City of Manassas, Virginia Architectural Review Board Meeting

ARCHITECTURAL REVIEW BOARD No. 2017-36

STAFF REPORT

ARB Case: 2017-36
Applicant: Rob Posch

PROPOSED FRONT ELEVATION WITH SINGLE CHIMNEY OPT. #1 DOOR WITH SIDE LIGHTS SCALE: 1/8" = 1'-0"

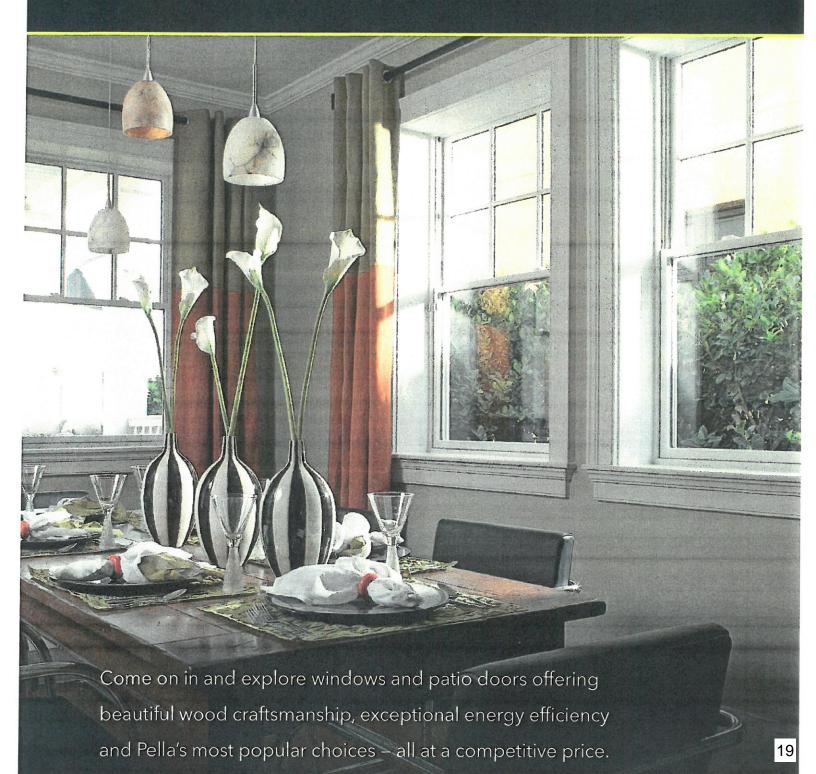
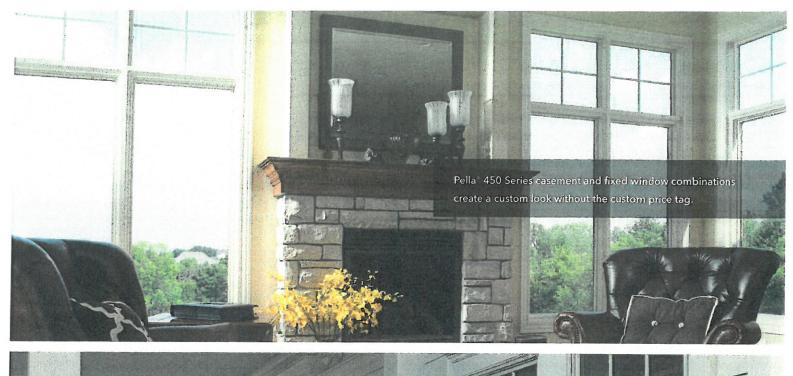
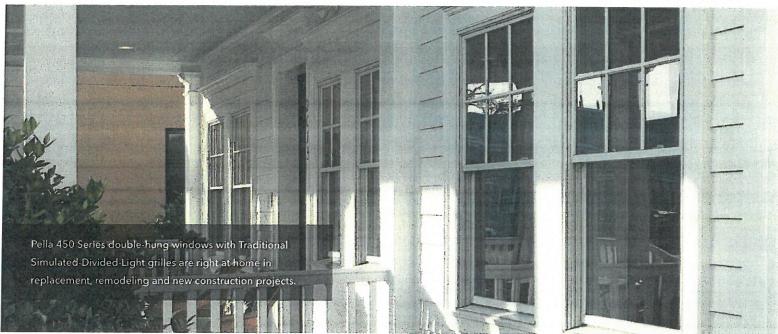
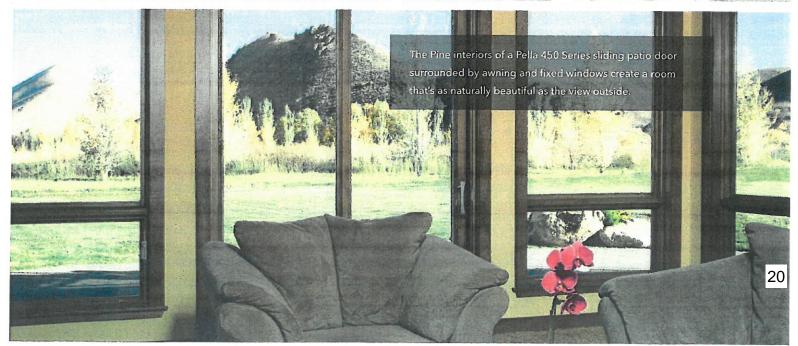
- <u>Doors</u> At the July 2017 meeting the Board approved the removal of the two entry doors to be replaced with a single entry door, which included transom and side lights, on the front elevation. For this month's meeting, the application would like approval of a second optional design, which would still be a single entry but without sidelights.

The applicable design guidelines for doors are found on pages 64-66 of the City of Manassas Historic District Handbook. The guidelines generally state that doors should only be replaced when they are missing and beyond repair. Original doors should be retained and can be weather-stripped. With the function of the structure changed from a duplex to a single family home, the Board approved at last month's meeting to change to a new single entrance that is sympathetic to the structure. This includes the use of a paneled door with transom above, respecting the existing doors, as well as the placement being centered on the elevation, respecting the symmetry of the home. This design included the use of sidelights which provided a consistent center width, in light of the double windows above on the 2nd floor and dormer. The applicant is requesting a second option for the front elevation, which is to eliminate the sidelights but retain the transom above the door. The applicant is still working on the final interior configuration of the structure, and based upon the final design they are unsure if they will be able to accommodate a front entry that includes sidelights. Staff believes both the sidelight option proposed last month and the non-sidelight options proposed this month have their merits. While the original design with the sidelights provides balance and rhythm in the vertical design of the structure, the non-sidelight option maintains a horizontal rhythm and is in keeping with the original doors of the structure which did not have sidelights. Staff supports approval of the option for a front door without sidelights. The applicant still needs to return to the Board with a final door panel design.

Recommendations for roofs can be found on pages 51-54 of the Historic District Handbook. The guidelines note that removal of original chimneys that contribute to the style and character of the building can reduce the visual integrity of the roof. The applicant is proposing removal of the southern chimney which has a significant amount of deterioration to the brick in the attic/2nd floor space. Deterioration in some areas of the chimney has resulted in sections where brick is completely disintegrated, resulting in holes in the chimney walls. In discussion with the applicant, it appears the chimneys were used as ventilation prior to wood burning stoves that would have heated the rooms of the structure; there are no fireplaces in the home. Since the structure was a duplex, each unit had its own chimney. In light of the limited contribution the chimney makes to the overall style and character of the house, the extent of deterioration to the chimney, and the conversion of the structure to a single family home, staff supports the applicant's proposal to remove the southern chimney and retain the northern chimney.

- Replacement of the existing wood windows with aluminum clad wood windows with simulated divided light.
- Permit the property owner the option to have the single front door with or without sidelights.
- Removal of the southern chimney.

- All windows will be of a 2/2 design; on the front elevation; this includes the change of the two center windows on the second floor and the two windows in the dormer from their current design to a 2/2 design.
- The owner may retain the existing four storm windows on the front elevation windows.

- Specifics of the design of the proposed front door panel.
- Any proposed changes to the roof material that do not constitute maintenance.
- Any proposed changes to the gutters that do not constitute maintenance.
- Any proposed changes to the trim that do not constitute maintenance.
- Any proposed changes to the front porch columns that do not constitute maintenance.
